Transmitted by the expert from Japan

Informal document No. GRSP-45-10
(45th GRSP, 25-29 May 2009,
agenda item 4(a))

Global technical regulation No. 9

PEDESTRIAN SAFETY

Figure 35: Test set-up for knee joint in static certification test (see paragraph 8.2.1.5.)

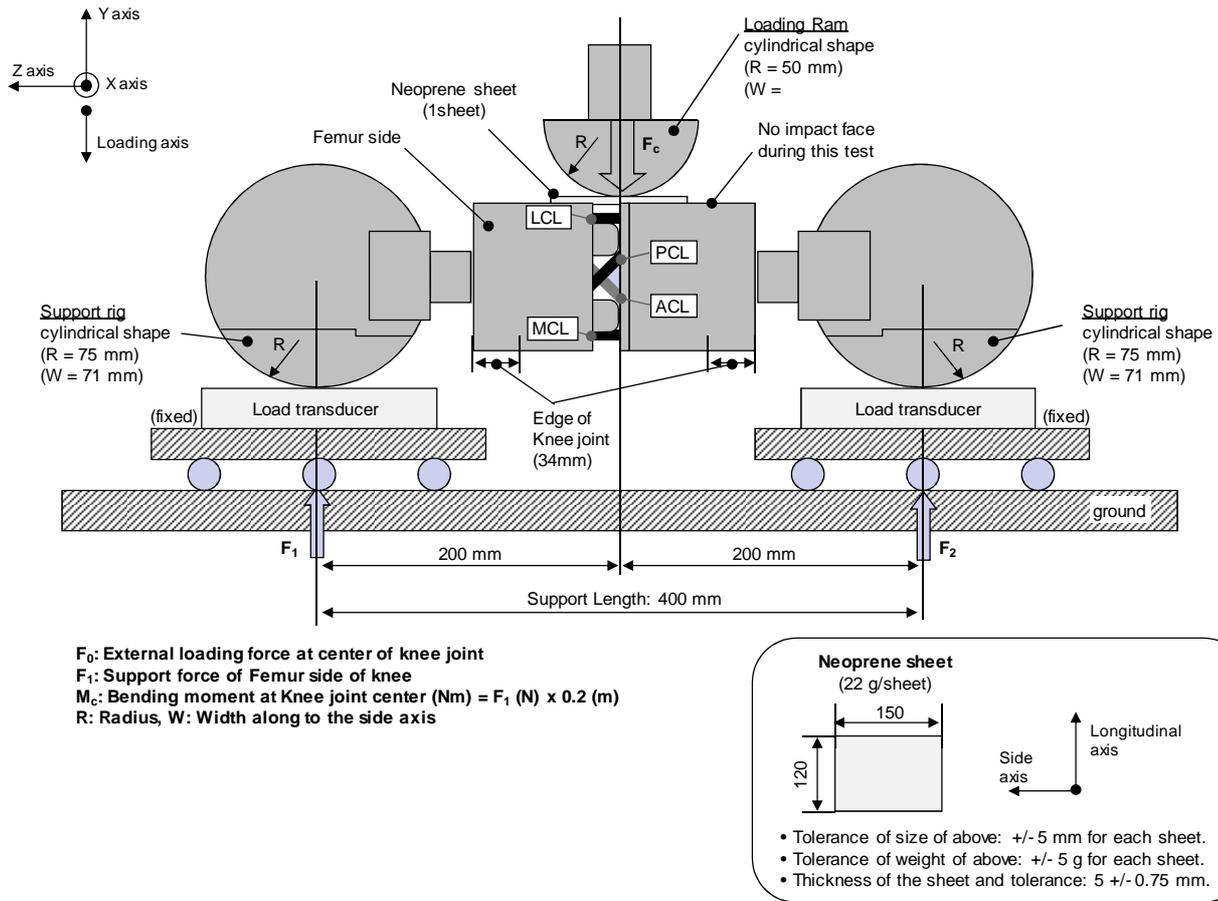
8.2.1.5. The edges of the knee joint, not bending parts, shall be mounted to the support rig firmly as shown in Figure 35. The Y axis of the impactor shall be parallel to the loading axis within $180 \pm 2^{\circ}$. In order to avoid friction errors, roller plates shall be set underneath the support rigs. To avoid impactor damage, a neoprene sheet shall be set underneath the loading ram and shall be removed

Figure 36: Test set-up for dynamic lower legform impactor certification test, Pendulum type (see paragraph 8.2.2.4.)

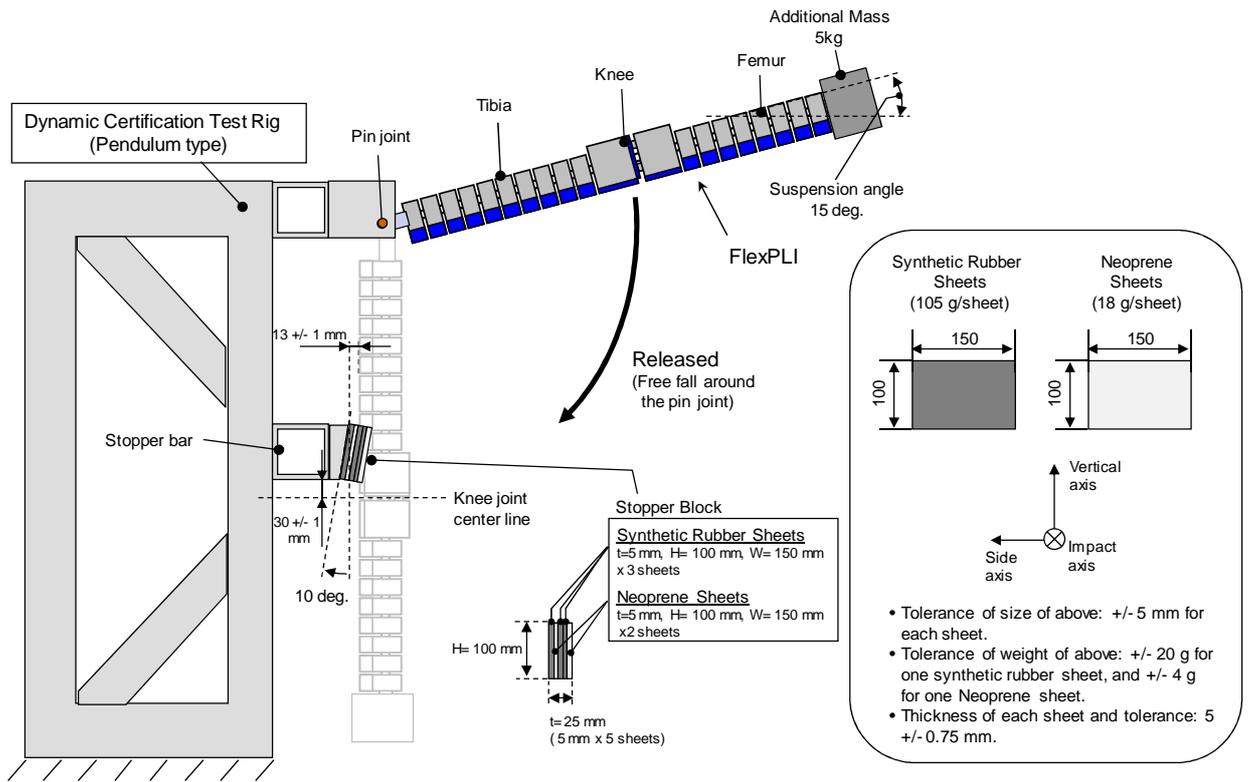
8.2.2.4.1. The impactor, excluding flesh, shall be suspended from the dynamic certification test rig $15 \pm 1^\circ$ upward from the horizontal as shown in Figure 36. The impactor shall be released from the suspended position, whereupon the impactor falls freely against the pin joint of the test rig as shown in Figure 36.

8.2.2.4.3. The knee joint centre of the impactor shall be $30 \pm [1]$ mm below the bottom line of the stopper bar, and the tibia impact face shall be located $13 \pm [1]$ mm from the front upper edge of the stopper bar when the stopper block is removed from the stopper bar and then hung from the impactor without any contact (see Figure 36).

Figure 37: Test set-up for stopper block certification test (see paragraph 8.2.2.4.)

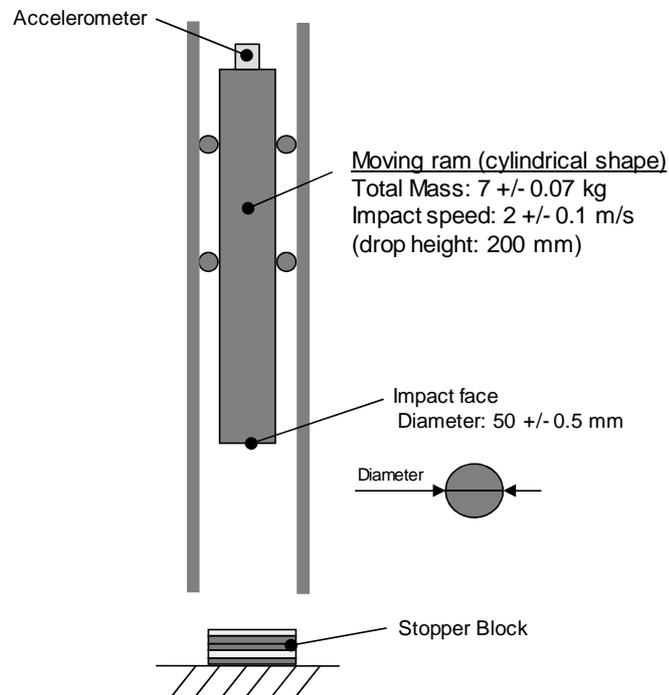
8.2.2.4.2. The stopper block, attached to the front of the stopper bar, shall have compression characteristics as shown in Figure 16 or shall generate maximum compression force from 3.5 to 4 kN when it is subjected to the drop test shown in Figure 37.

Figure 38: Test set-up for dynamic lower legform impactor certification test, Inverse type (see paragraph 8.2.3.4.)

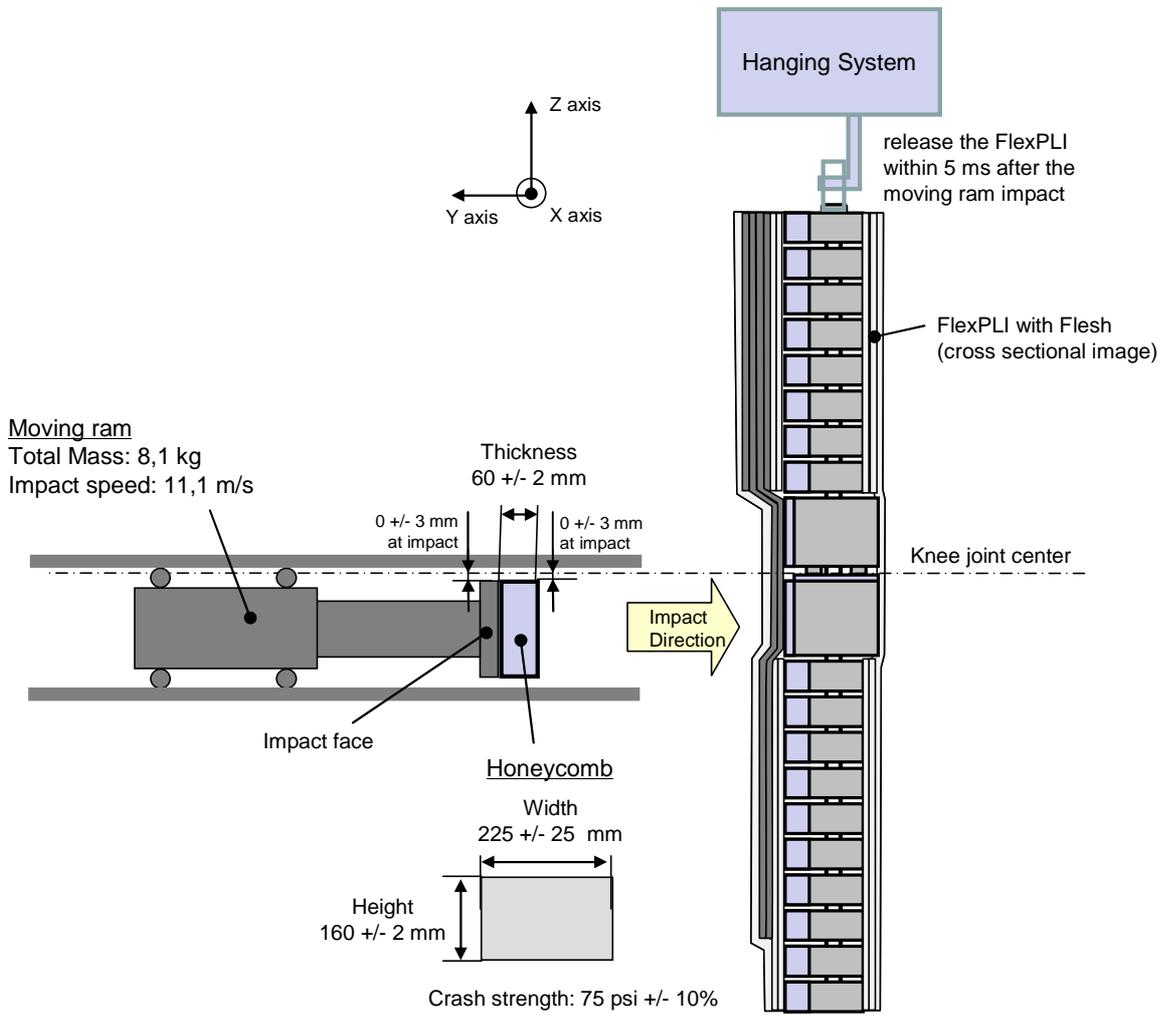
8.2.3.4.1. The impactor covered by flesh shall be hung vertically as shown in Figure 38. The impactor shall be impacted by a moving ram of 8.1 ± 0.1 kg mass, at an impact speed of 11.1 ± 0.2 m/s. The impactor shall be released from the hanging system within 5 ms after the moving ram impacts the impactor.

8.2.3.4.2. The honeycomb, which is attached in front of the moving ram, shall have a crash strength of 75 ± 7.5 psi, and it shall have the dimensions shown in Figure 38.
